BODY

■ FRONT BODY

1. Radiator Support Assembly

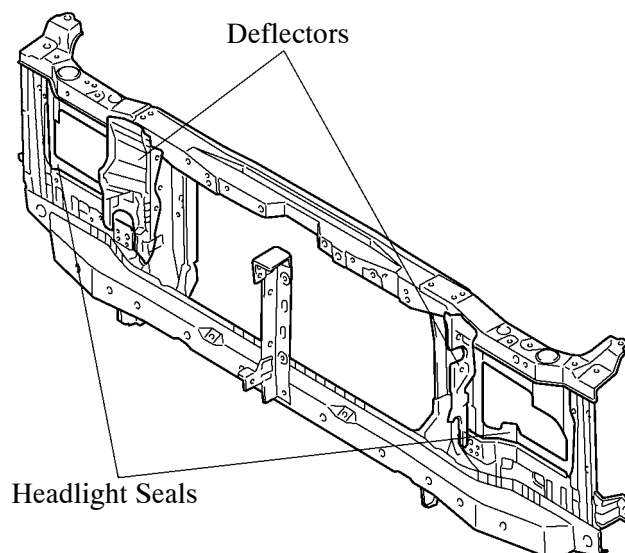
- Along with the introduction of the 1VD-FTV engine models, the front tread has been widened on all models. Accordingly, the radiator support has been widened.
- Along with the change in the design of the headlights and the radiator grille, the construction has been changed.

3. Hood Assembly

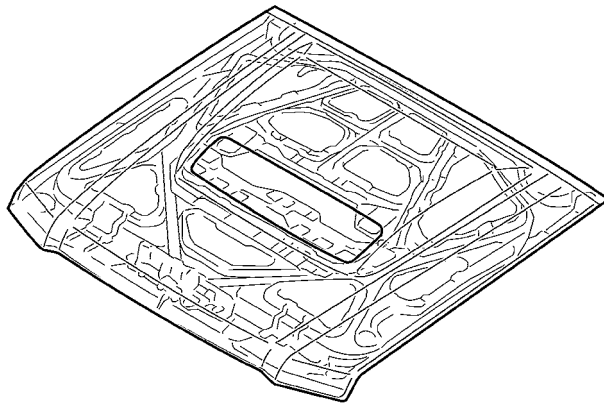
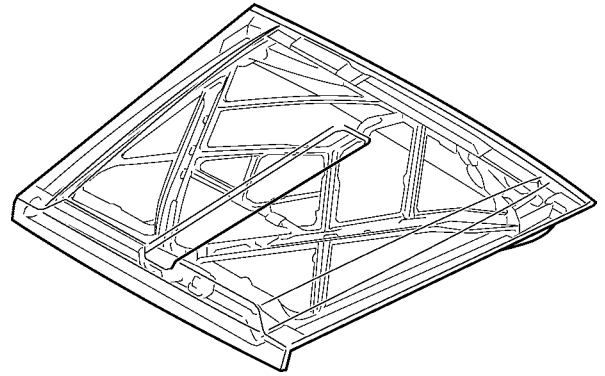
- Along with the introduction of the 1VD-FTV engine models, the design of the hood has been changed.

A – A Cross Section

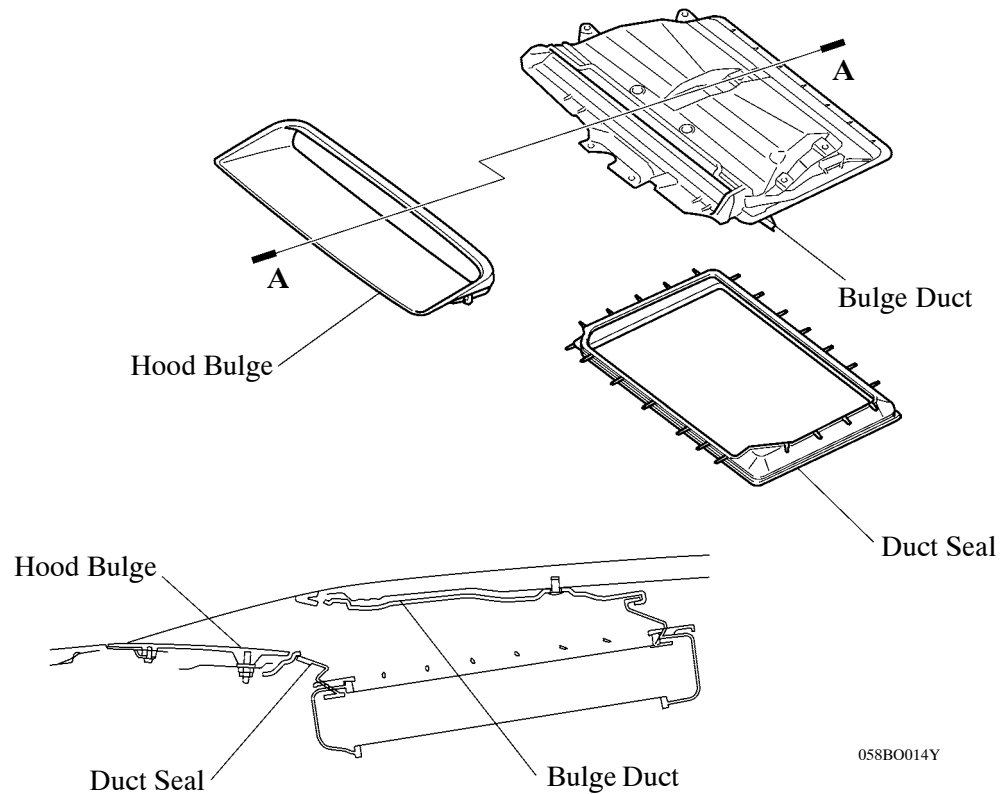
- Along with the introduction of the 1VD-FTV engine models, a hood bulge is provided.

4. Apron Assembly

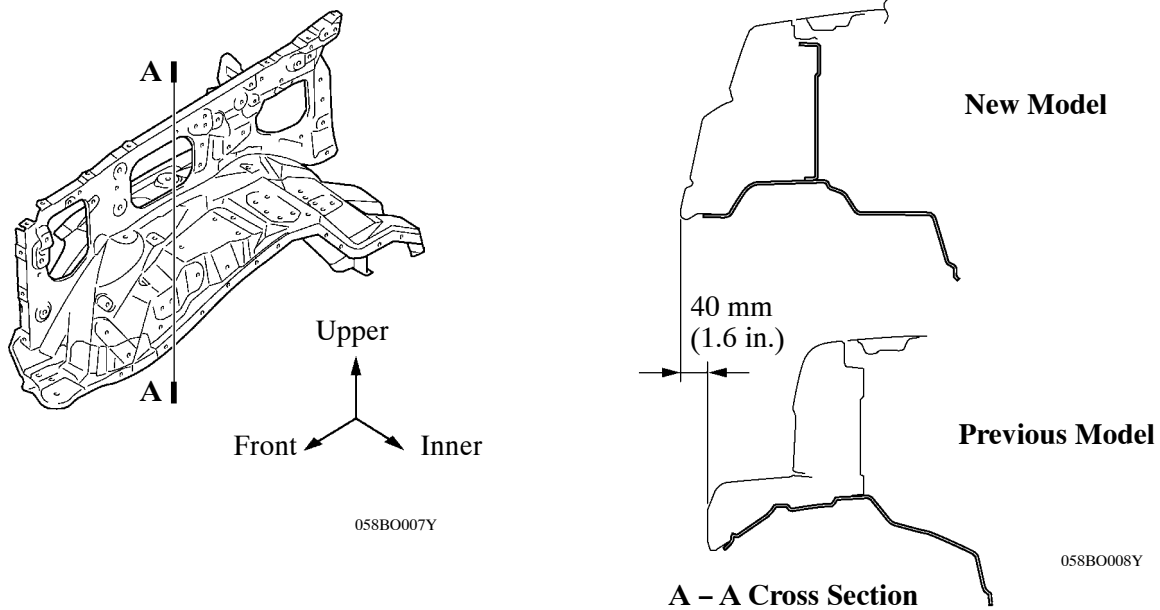
Along with the introduction of the 1VD-FTV engine models, the front tread has been widened on all models. Accordingly, the apron has been widened.

5. Fender Assembly

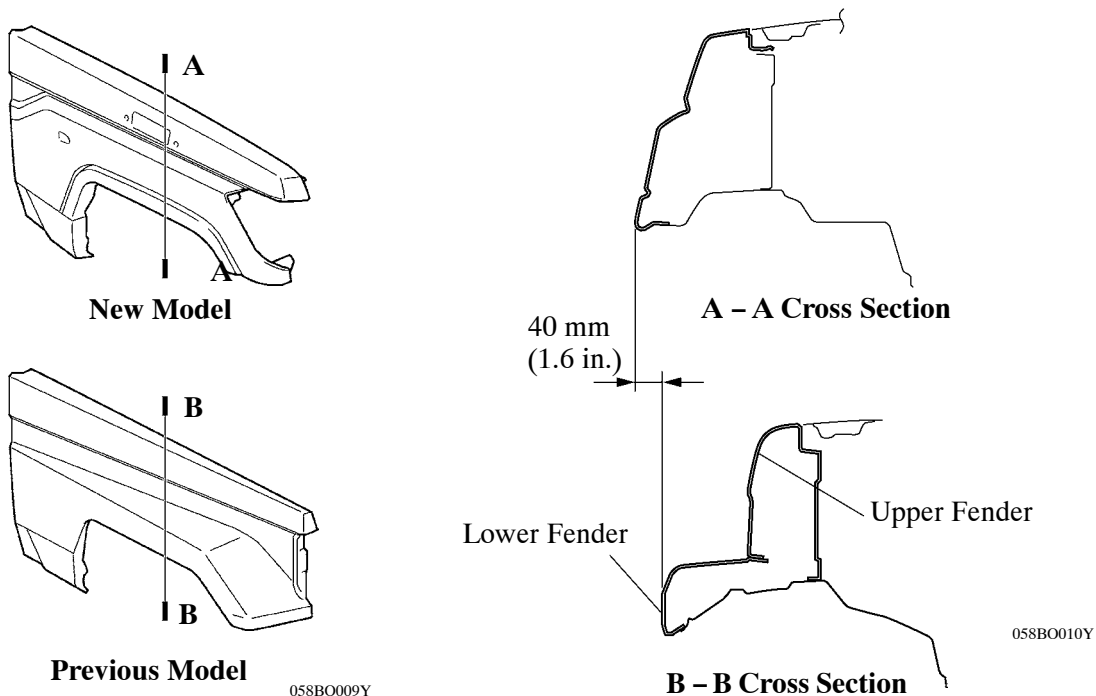
- Along with the introduction of the 1VD-FTV engine models, the front tread has been widened on all models. Accordingly, the fender has been widened.
- Along with the provision of the front body, the design has been changed.
- Along with the integration of the upper and lower fenders, the construction of the fender assembly has been changed.

6. Dash Panel Assembly

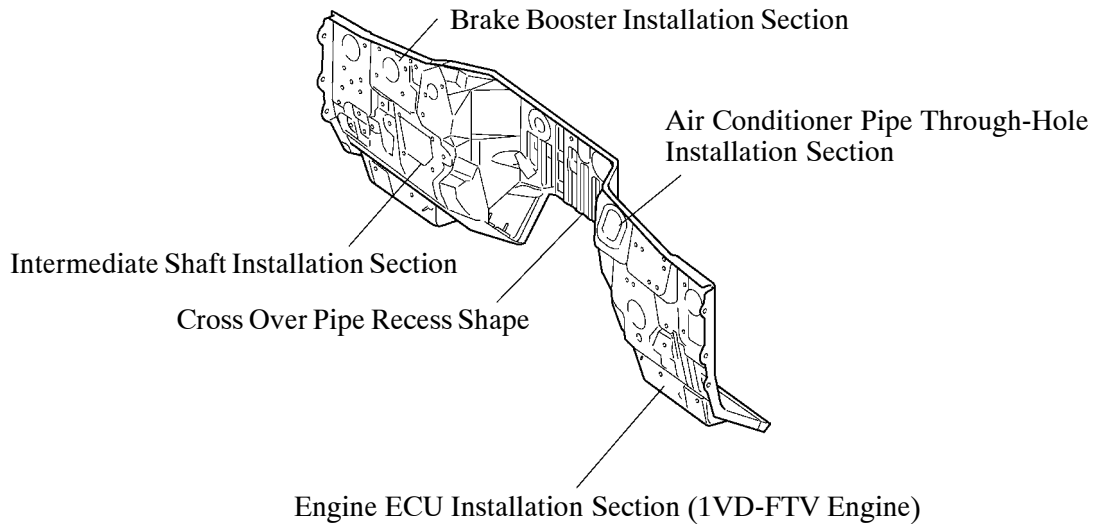
Along with the introduction of the 1VD-FTV engine models, the sections for installing the brake booster, intermediate shaft, and the through-holes for the air conditioner pipe have been changed. Also, a recess shape for the cross over pipe and a section for installing the engine ECU for the 1VD-FTV engine have been added.

7. Cowl Assembly

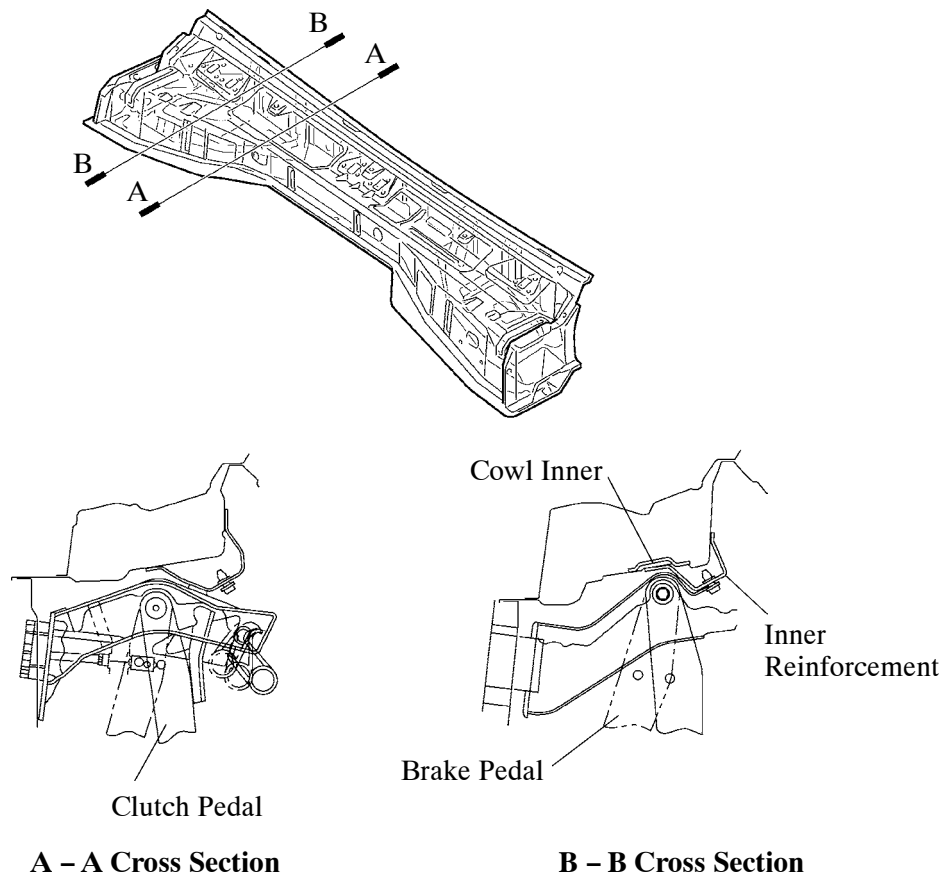
Along with the introduction of the 1VD-FTV engine models, the brake pedal has been changed. Consequently, the shape of the cowl inner has been changed and an inner reinforcement is provided.

8. Front Body Silencer

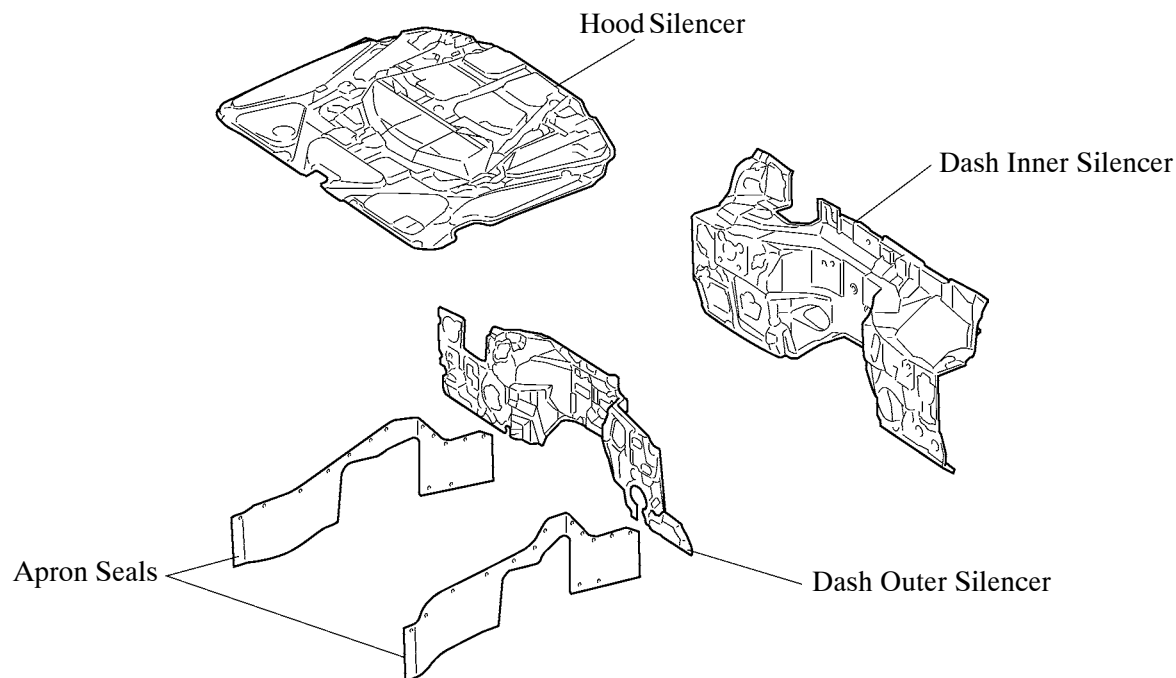
Along with the introduction of the 1VD-FTV engine models, a front body is provided. Consequently, silencers and seals are provided in various areas of the front body.

9. Engine Under Cover

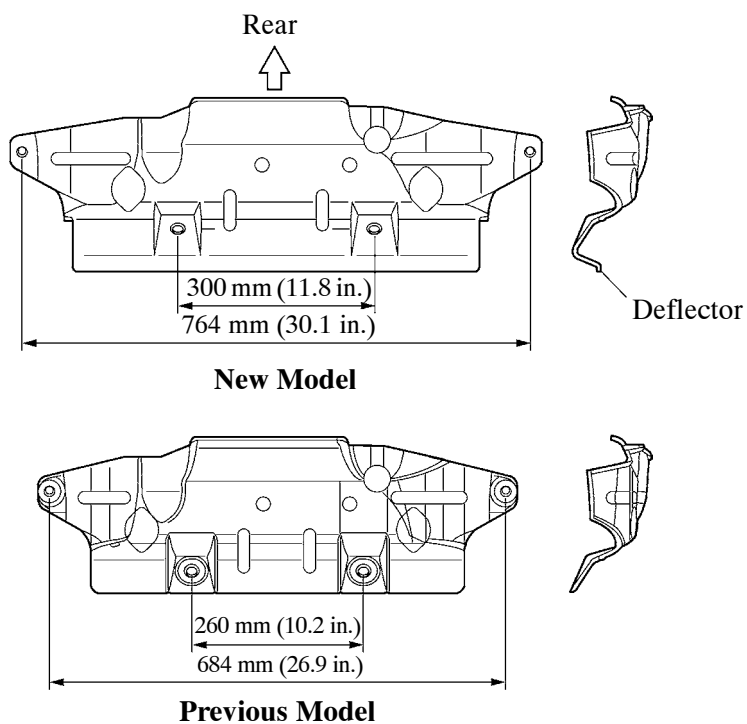
Along with the introduction of the 1VD-FTV engine models, the front tread has been widened on all models. Consequently, the engine under cover has been widened, and a deflector is provided to deflect the warm air.
